**Response of the Greenburgh Environmental Forum LORAX Working Group  
to the New York State Public Service Commission (PSC) Case 10-E-0155  
Draft Recommendations Dated December 31, 2010**

**Final Revision - February 1, 2011**

The GEF LORAX Working Group submits the following response to the PSC's draft recommendations issued on December 31, 2010. Our response is divided into two parts: part 1 contains **general comments** regarding the draft recommendations and/or pertains to Case 10-E-0155 overall, and part 2 contains detailed **comments on specific draft recommendations**.

**Tree heights conforming to distance requirement to avoid arcing for 242 kV lines.**

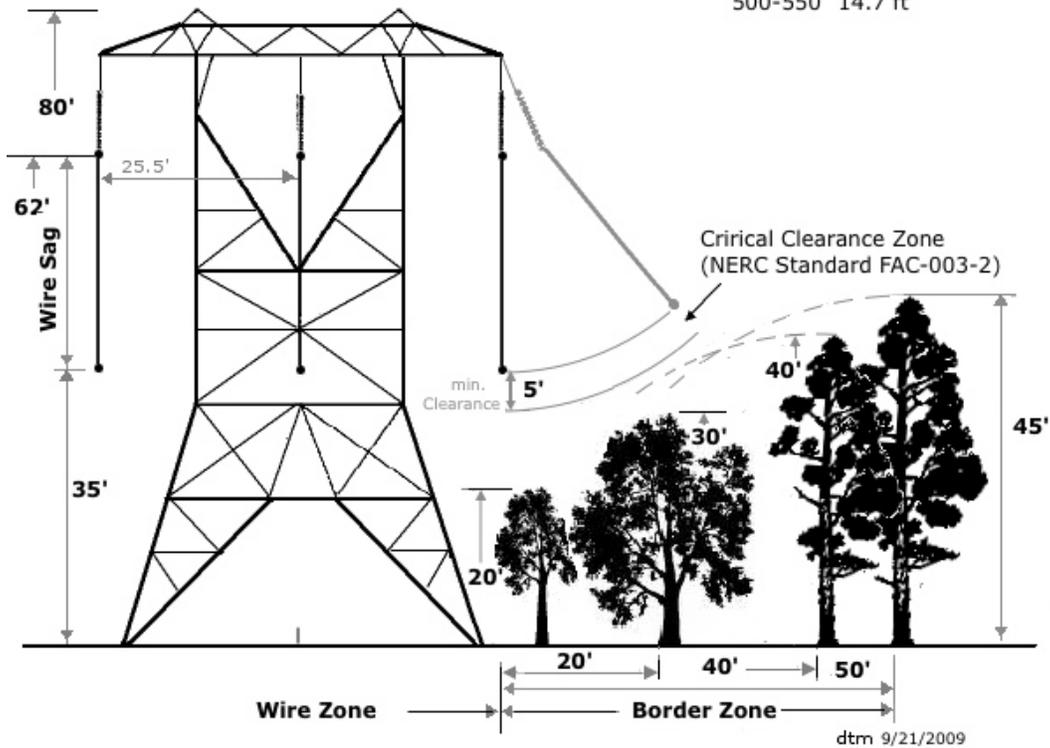
**LORAX Comments:** The core problem with this recommendation is found in the final sentence: "Each utility will utilize its own expertise to determine when, where, and under what conditions this management practice will be employed." In our region, both Con Edison and O&R have already demonstrated repeatedly that they have no concern for actual vegetation risk and have instead relied upon a strict adherence to a "one size fits all" clear-cutting methodology. So, in actual practice, over and over again, this "self-regulation" has been shown not to work. Perhaps in the case of the worst offending TOs, a third party analysis, review, and on-site supervision of TVMPs is required. Such oversight and audit services would best be provided by fully independent firms who have qualified environmental science resources available.

Utility assertions about envisioned "ecologically sound," "natural" restoration after clear-cutting (or any other extreme management practices which cause widespread ecosystem disruption and soil disturbances) must be accompanied by detailed analysis of the actual ecological conditions (e.g.: a full spectrum bio survey) at specific/representative locations along the ROW pre- and post-vegetation management. Impact analysis should also utilize USDA Forest Service tree valuation criteria which allows calculation of lost ecosystem services such as carbon sequestration, oxygen generation, stormwater and erosion control, etc. This will help provide a numeric basis for evaluating mitigation requirements. Post-management plans should be based on current scientific research and updated "best practices" - *see note below about ANSI IVM issues.*

Comments elsewhere in this LORAX response mention "Tiered" Vegetation Management practices in general terms. The PSC should develop specific representative diagrams detailing safety clearance heights based upon line voltage and the distance from the centerline (or by FERC FAC-003 wire zone safety clearances). [*See for example this diagram below from the Raritan, NJ Sierra Club:*]
